TO: Residential Distributors and Dealers
From: Technical Service Department
Date: November 19, 2009
Re: Mis-wiring of B4VM-E, B5VM-E, PAH2VM-E and PAH4VM-E

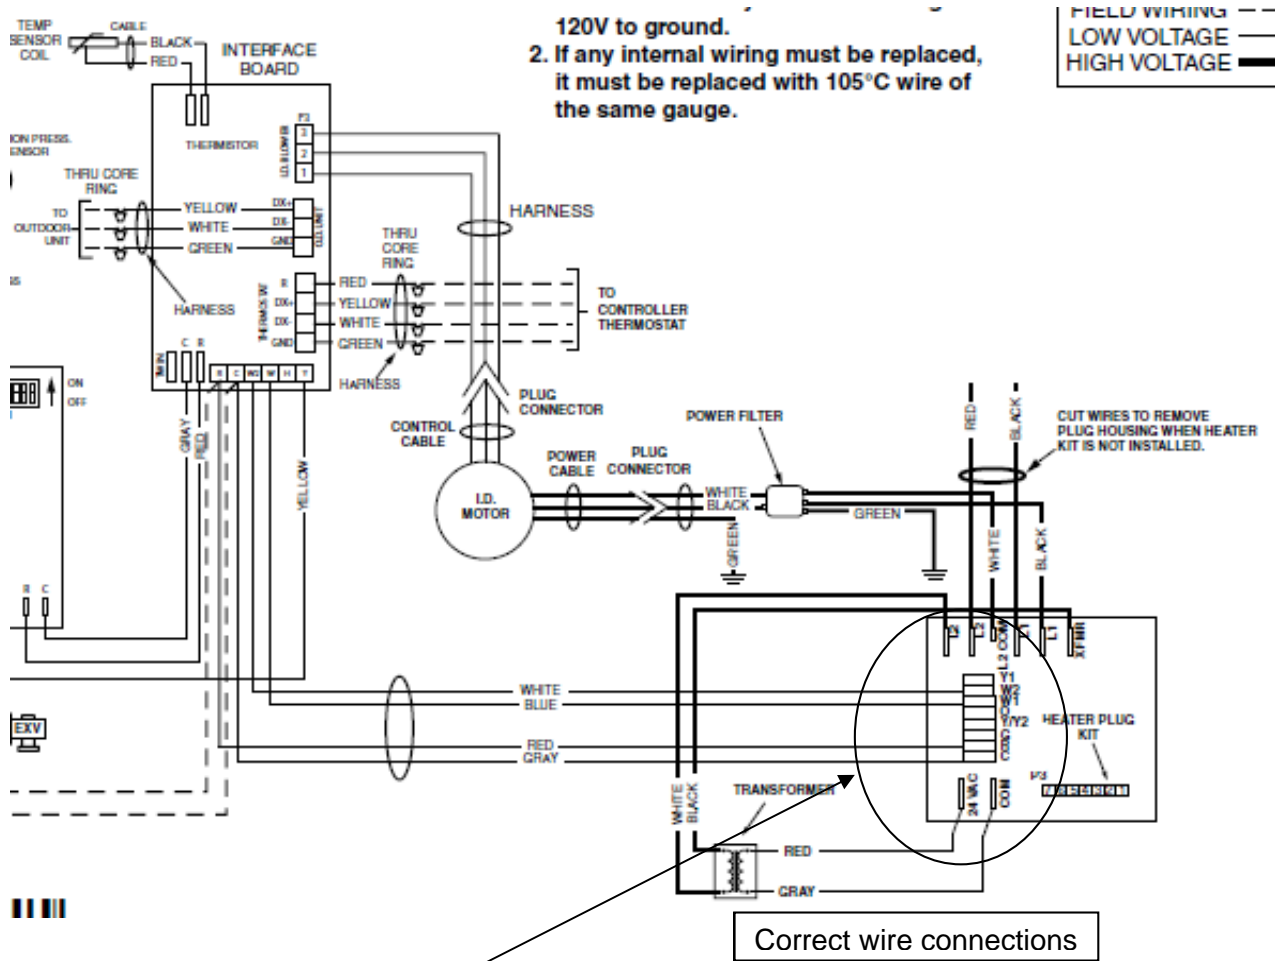
Nordyne is aware of a wiring issue with the above mentioned air handlers. Specifically, the two wires that connect W1 and W2 of the harness at air handler board to W1 and W2 to the screw terminals of the interface board located in the blower section of the air handler.

The wires of the harness at the air handler board could be located at terminals Y and W2. The result is that the auxiliary heat (strip heat) will not work properly.

If you have this issue, the corrective action is to power down the air handler, cut and strip the wires going to the harness on the air handler board and attach the wires to the terminal strip.

Take the red wire from the "R" terminal on the interface board and attach it to the "R" terminal on the air handler board, The grey wire attached to the "C" terminal on the interface board and attach to the "C" terminal on the air handler, take the blue wire attached to the "W" terminal on the interface board and attach it to the "W1" terminal on the air handler board, and take the white "W2" wire from the interface board and attach the wire to the "W2" terminal on the air handler board.
